BAR Meeting
February 18, 2015

ISSUE: Permit to Demolish/Capsulate and Addition/Alterations

LOCATION: 222 South Fairfax Street

BAR2015-00012 & BAR2015-00013

① FIRST FLOOR PLAN - EXISTING & DEMOLITION

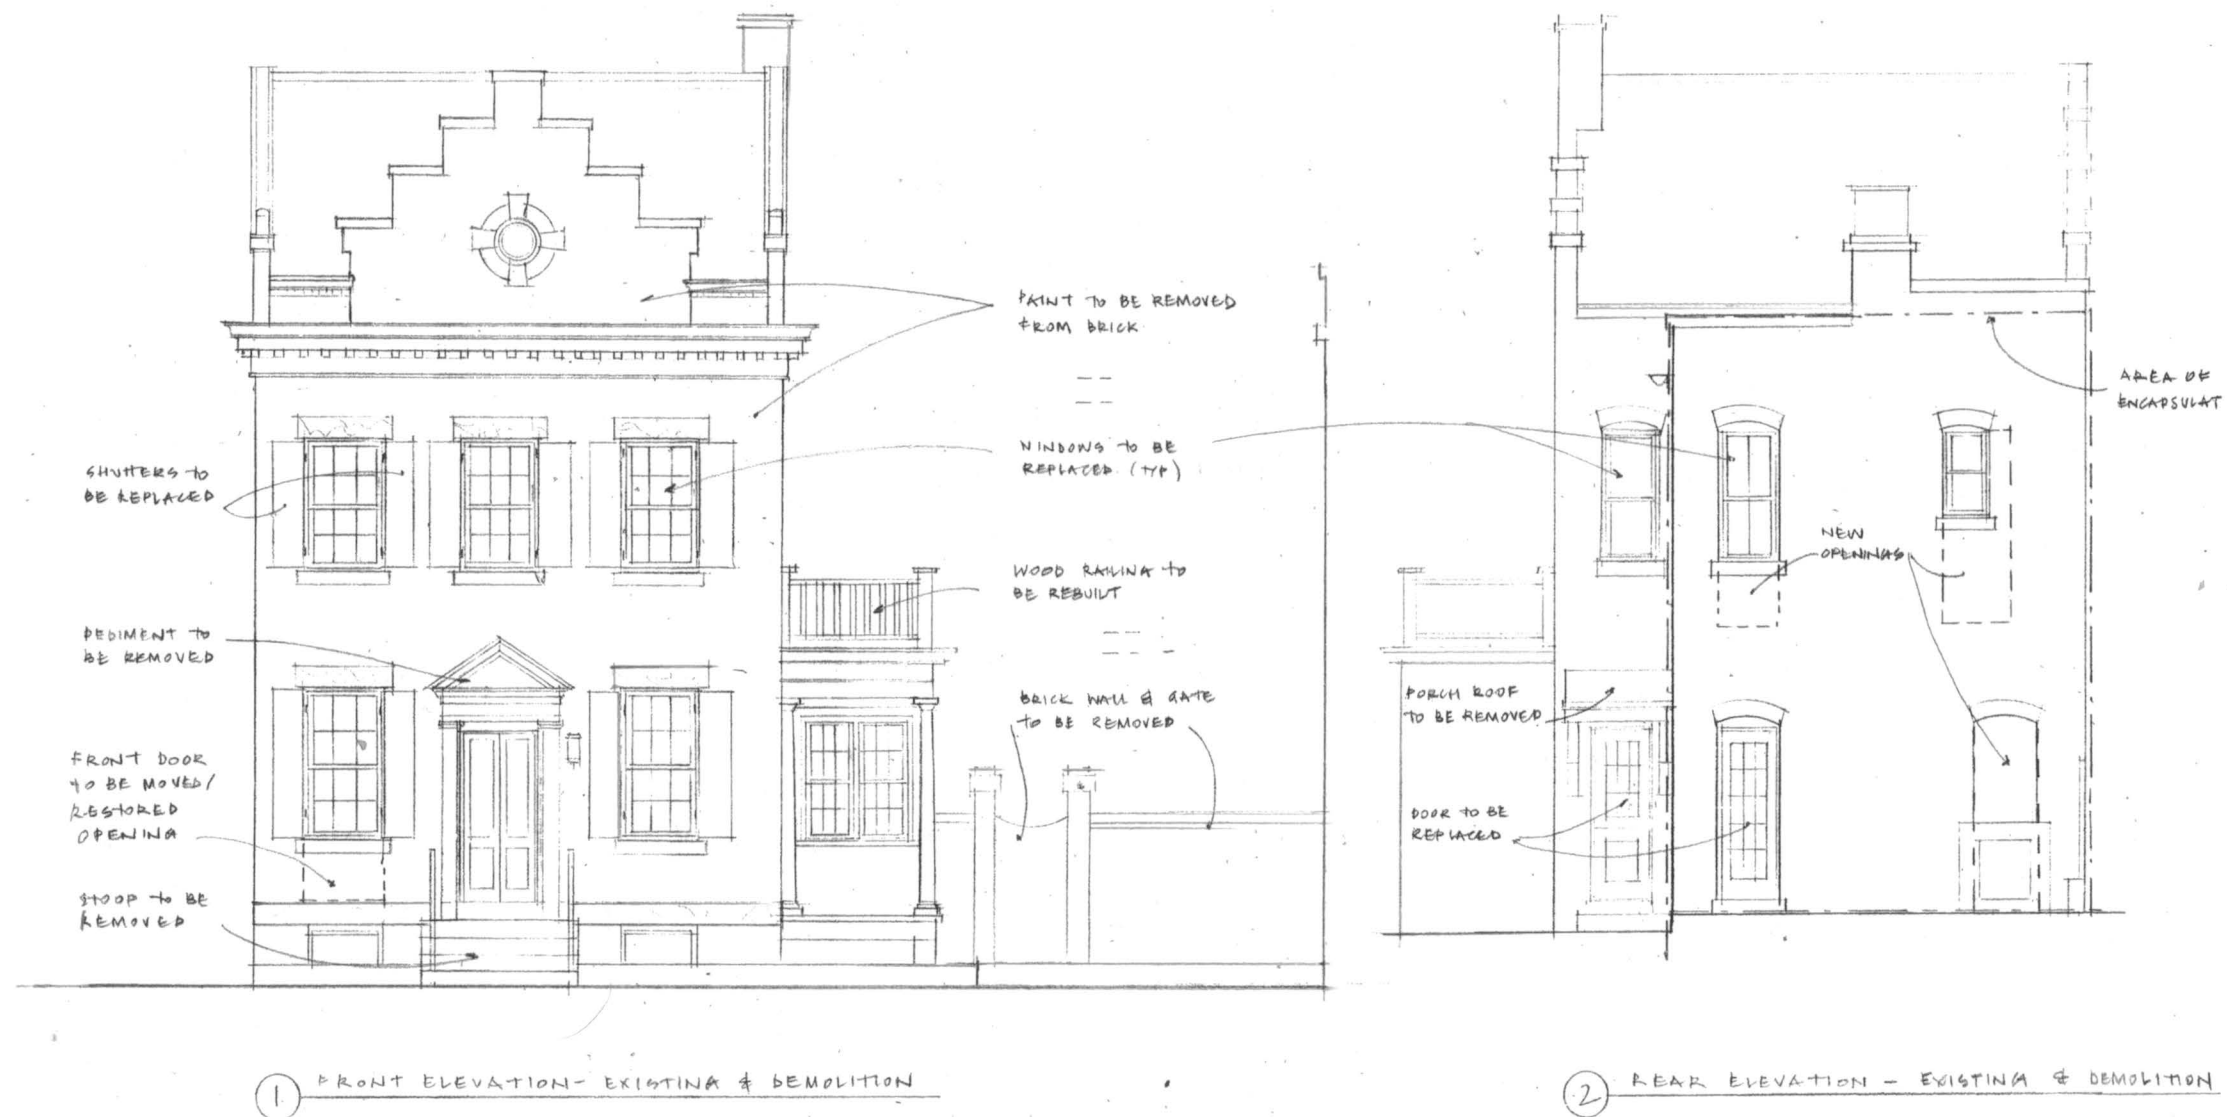
- Demolish existing front stoop
- Demolish existing brick garden wall
- Demolish bay window on south elevation
- Remove rear porch roof
- Demolish portions of east wall on rear ell for new doorways and capsulate remaining area on east wall of rear ell
- Capsulate portion of first floor on south elevation rear ell
- Demolish below-grade areas for enlarged basement windows on south side elevation

① FIRST FLOOR PLAN - PROPOSED

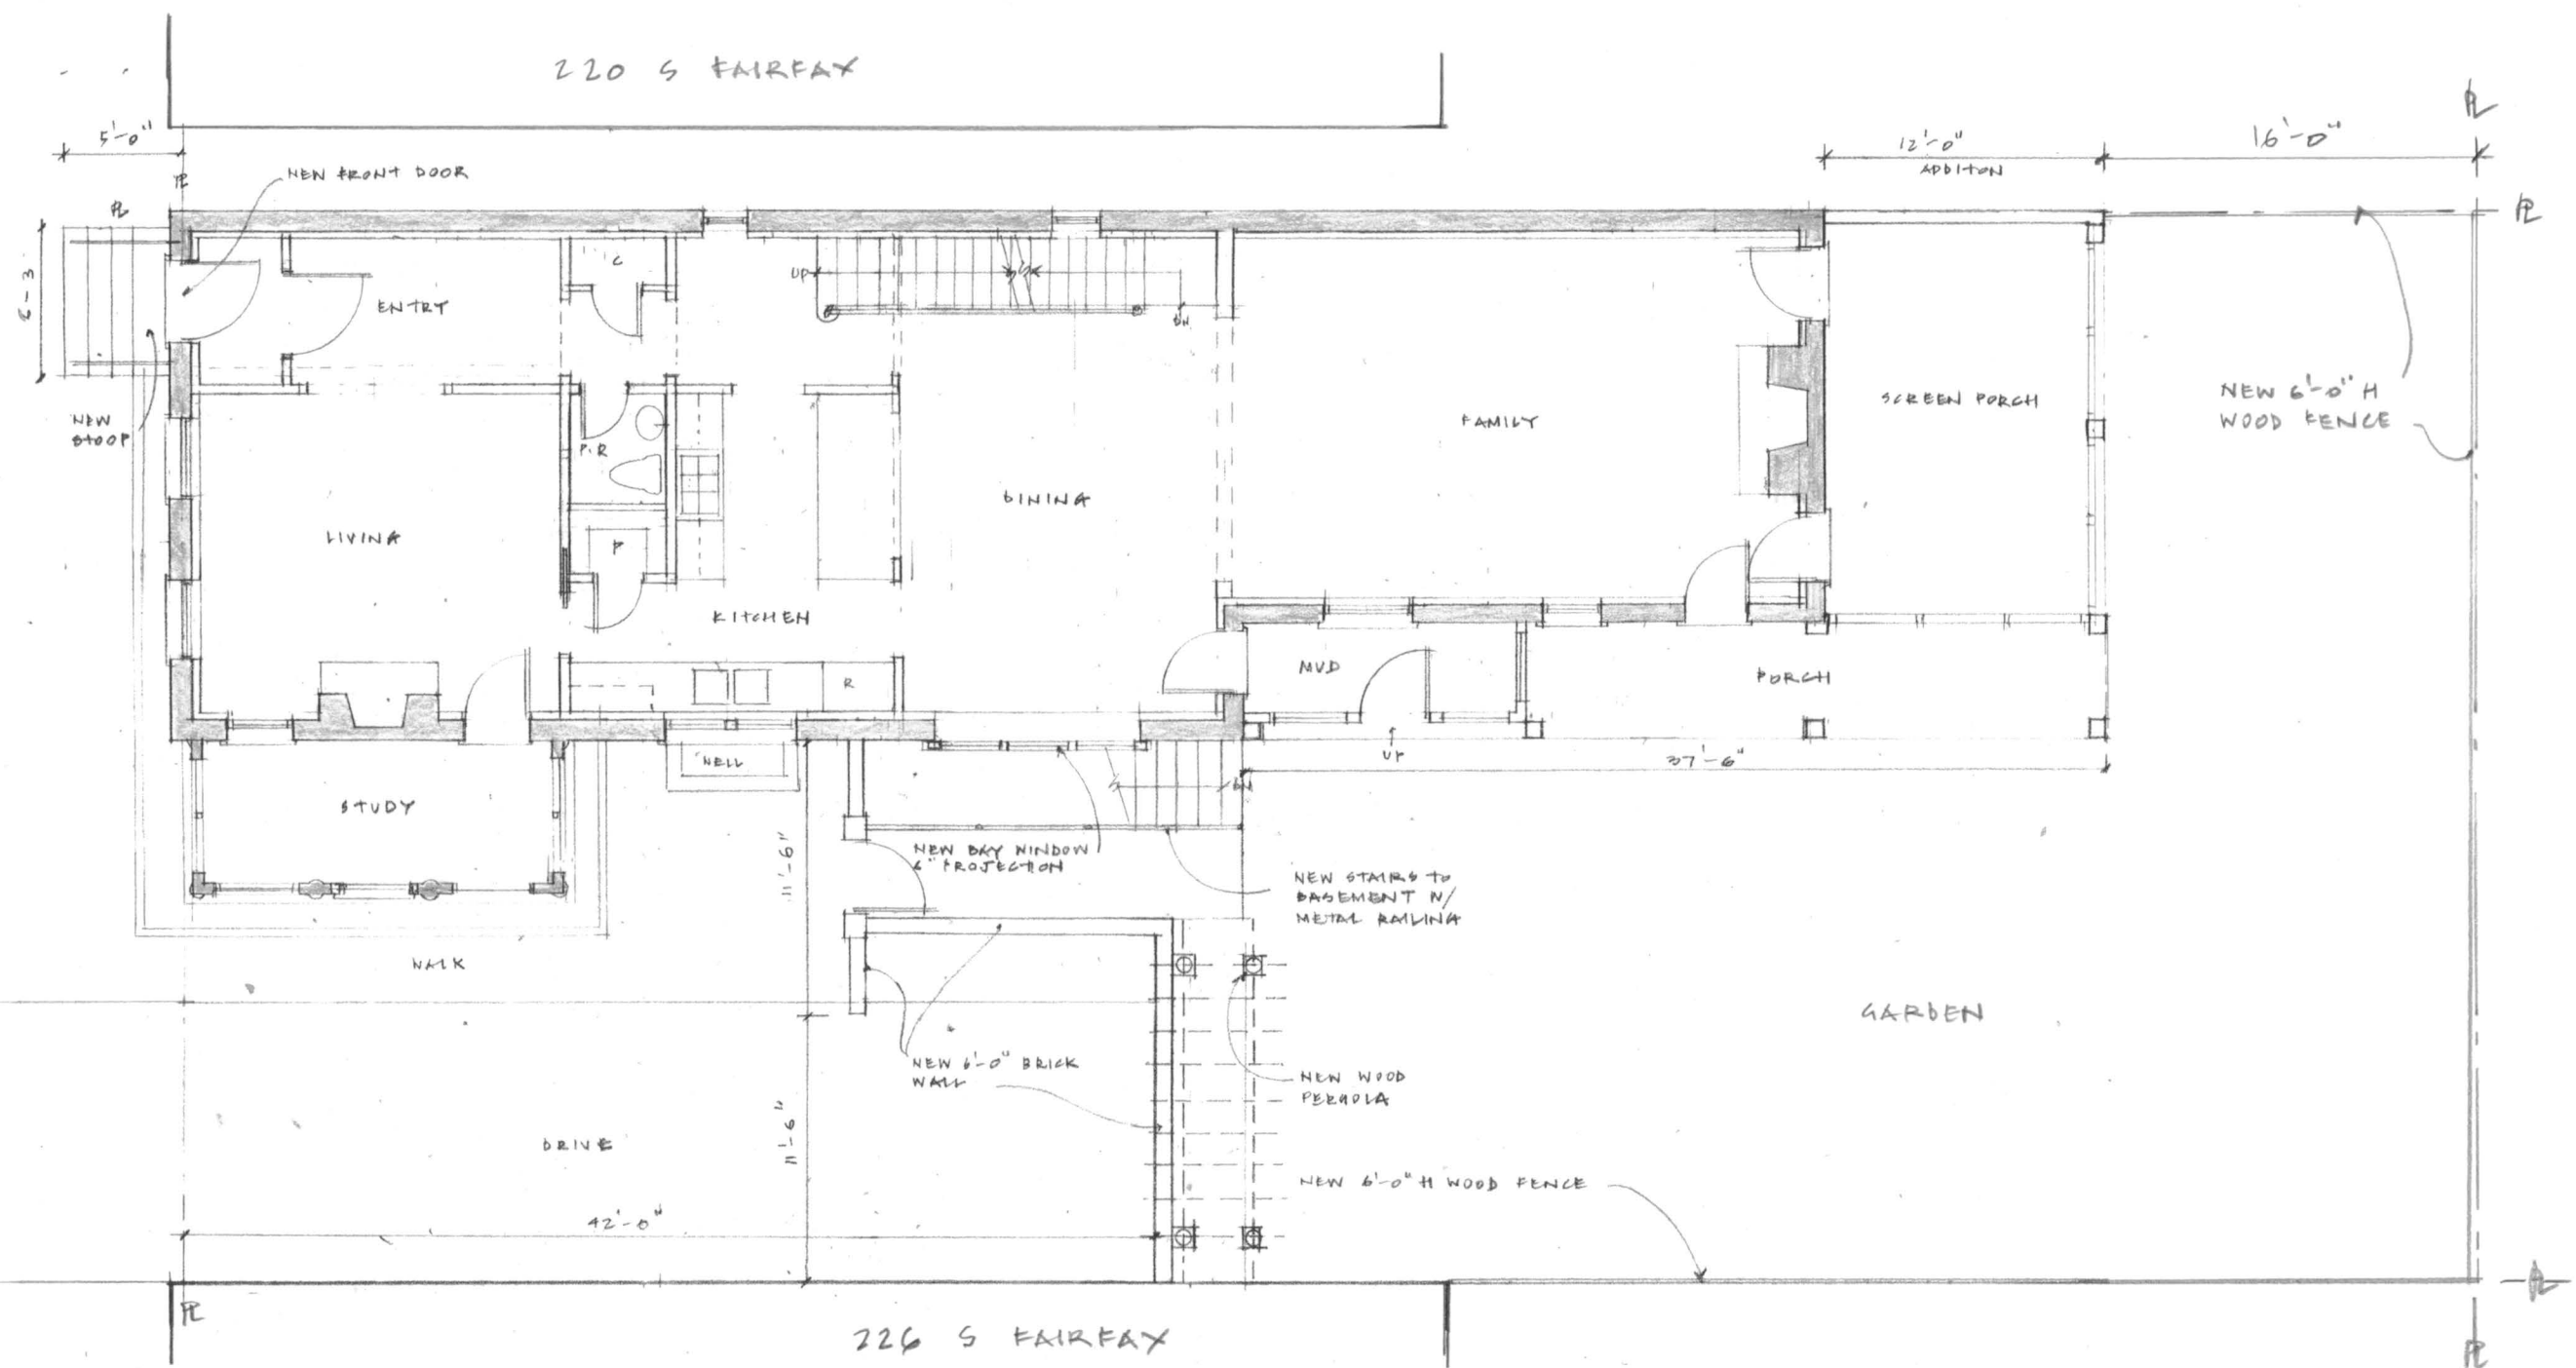
3. The applicant shall submit specifications for the replacement front door for final staff approval in conformance with the BAR's adopted policy.
4. The front stoop shall be revised to only encroach four feet into the public right-of-way, or the owner may obtain an encroachment from City Council prior to issuance of a building permit for a greater encroachment.

The proposed alterations and addition comply with the zoning ordinance by using both of the historic lots. While this property is comprised of what was once two separate lots, the existing side porch and proposed basement steps cross the property line. Additionally, the second lot provides the required open space for the lot the house is on, permitting the proposed addition to be constructed in conformance with zoning ordinance requirements and precluding separate future development on the adjacent lot. As proposed, the new front stoop will encroach five feet into the public right-of-way. The stoop may only encroach four feet without having to obtain an encroachment from City Council.

multi-pane doors on the side elevation as well as a multi-paned bow window. Therefore, staff fully supports the proposal to return the front entrance to the side bay and to construct a new stoop. The proposed door, trim and matching stone lintel are all appropriate. Staff finds that one-over-one windows would be more appropriate than two-over-two. Historically, property owners installed smaller panes of glass on side elevations and the largest—and most expensive—panes on the front elevation. As this house appears to have had one-over-one windows on the side elevation of the main block and two-over-two windows on the rear ell, it seems most appropriate that the front elevation have one-over-one windows. This is also consistent with the higher style possessed by this house with its pronounced stepped pediment within a mansard roof, an unusual element on this Victorian building. Therefore, staff conditions approval on the condition that the front windows have a one-over-one light configuration and that the specifications meet the Board's adopted Window Policy.

JELD WEN Simulated Divided Lites

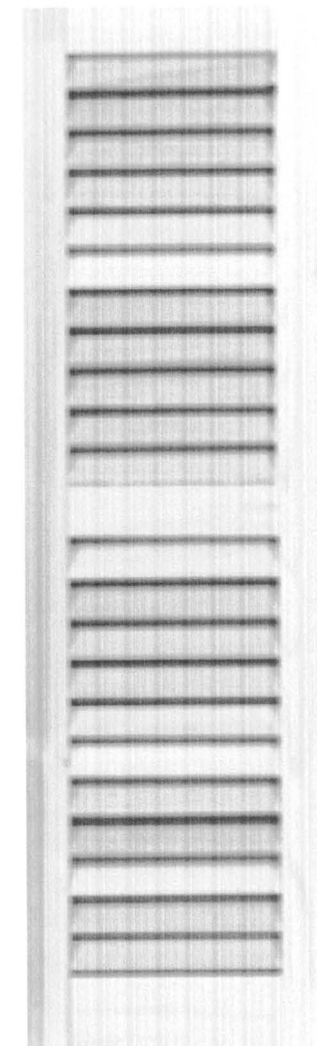
2. The front windows shall be one-over-one instead of two-over-two. The applicant shall submit specifications for final approval by staff in conformance with the BAR's adopted Window Policy.
